TOWN OF  
**BRECKENRIDGE**

**Planning Commission Meeting Agenda**

Tuesday, November 3, 2020, 5:30 PM

1. Breckenridge Distillery Pavilion (JL), 1925 Airport Rd., PL-2020-0465 13

**A4.0**  
RCP

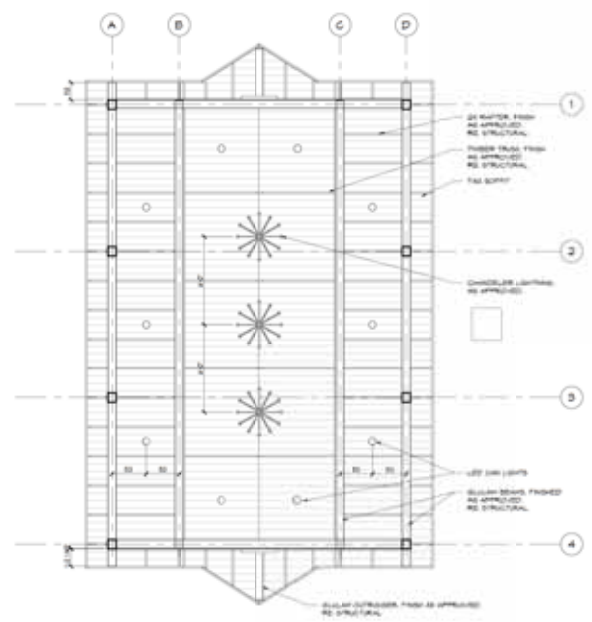
**Exterior Lighting:** Three unshielded chandeliers are proposed underneath the roof structure. Staff finds that the chandeliers will be installed such that the light source will not drop below the enclosed roof which is under the 18 foot maximum height allowed for commercial uses. A condition of approval has been added to prohibit the chandeliers to be below the horizontal plane of the enclosed roof at any time. Six LED can lights are proposed to be recessed in the soffit 8 feet from finished grade. The LEDs are soft white lights, 10.2 watt and 723 lumen, under the maximum allowed. A photometric plan is required to be submitted meeting the Exterior Lighting Chapter requirements prior to the issuance of a building permit and has been added as a Condition of Approval.

- 8. The chandelier lighting shall not extend below the horizontal plane of the enclosed roof, resulting in the unshielded fixture to be visible outside of the Pavilion at any time.**

- 19. A photometric plan for the Pavilion lighting shall be submitted in conformance with the Exterior Lighting Chapter, Lighting Zone 3.**

**2 FIREPLACE - WEST ELEVATION**  
A1.0 1/2" x 1'-0"

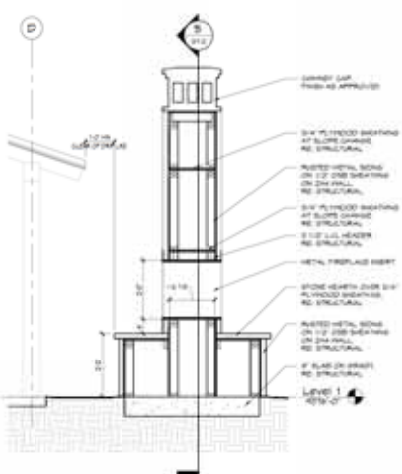
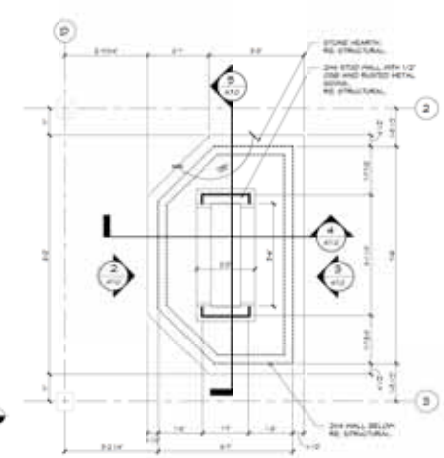
**Air Quality (30/A):** This absolute policy states, (4) *Restaurant or bar: One EPA-certified wood burning appliance per restaurant or bar, or restaurant/bar combined. (Ord. 1, Series 2019).* The applicant has confirmed that there is no existing wood burning appliance on site. Staff finds that the wood burning fireplace would be allowed. The applicant has provided a spec sheet for the fireplace to confirm that it meets the EPA Phase II required by code. Staff has no concerns.

- 14. Plans shall be revised to reflect the fireplace as single sided, opening to the west elevation only.**
15. Applicant shall identify all existing trees, which are specified on the site plan to be retained, by erecting temporary fence barriers around the trees to prevent unnecessary root compaction during construction. Construction disturbance shall not occur beyond the fence barriers, and dirt and construction materials or debris shall not be placed on the fencing. The temporary fence barriers are to remain in place until issuance of the Certificate of Occupancy.

**West Elevation Areas**

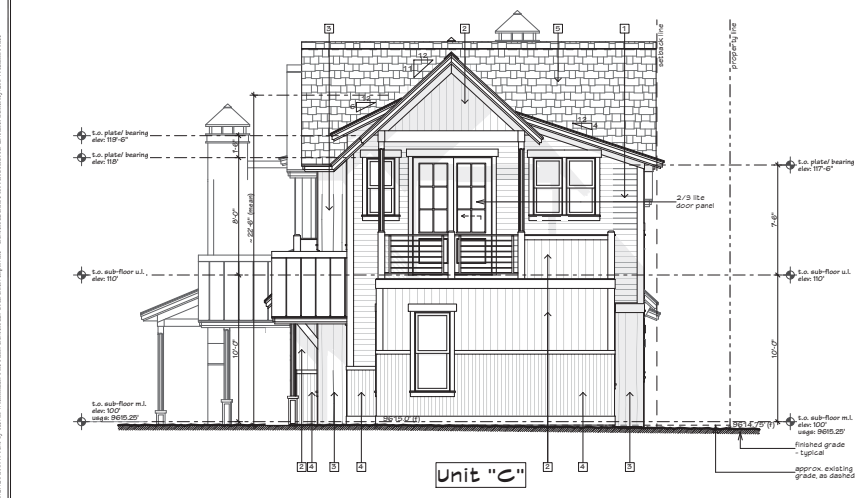
Ms. Leidal: Luke mentioned 1 or 2 walls exceeded the threshold of 25% non-natural materials and needed a condition of approval. Were the plans revised? (Mr. Kulick: No, we can clearly request that as a Condition of Approval and create a new condition #11 to not exceed 25% non-natural materials on any elevation).

Mr. Mike Bieg, owner of 217 Wellington: We did resubmit those drawings on the exterior to meet the non-natural requirements. (Mr. Kulick: Plans in PC packet were not updated so we will add the COA).
